Technical Bulletin

Subject: **Power terminal detachment during installation**

Product: SSC10-100
SSC10-150
SSC10-200
SSC32-275

Date: August 14, 2006

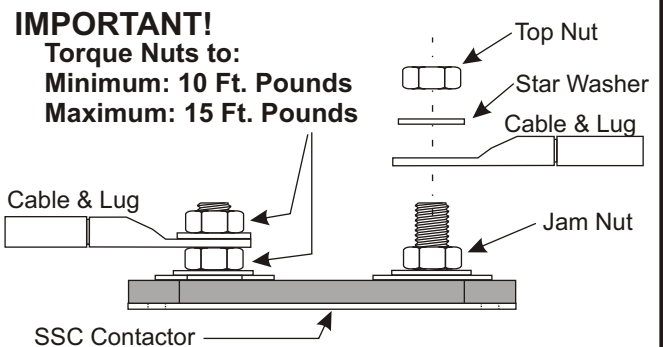
Problem: The power terminal consists of a 3/8 - 16 threaded stud that is screwed into a cylindrical brass contact pad. The brass contact pad is soldered to a circuit board. The contact pad and stud have been designed to handle many times the recommended torque. However, if the stud is allowed to rotate in the contact pad it could act as a jack screw and pull the contact pad off the printed circuit board.

INCORRECT ASSEMBLY METHOD

CORRECT ASSEMBLY METHOD

Solution: To prevent the problem, a jam nut must first be installed, locking the stud to the contact pad, thereby preventing the rotation of the stud.
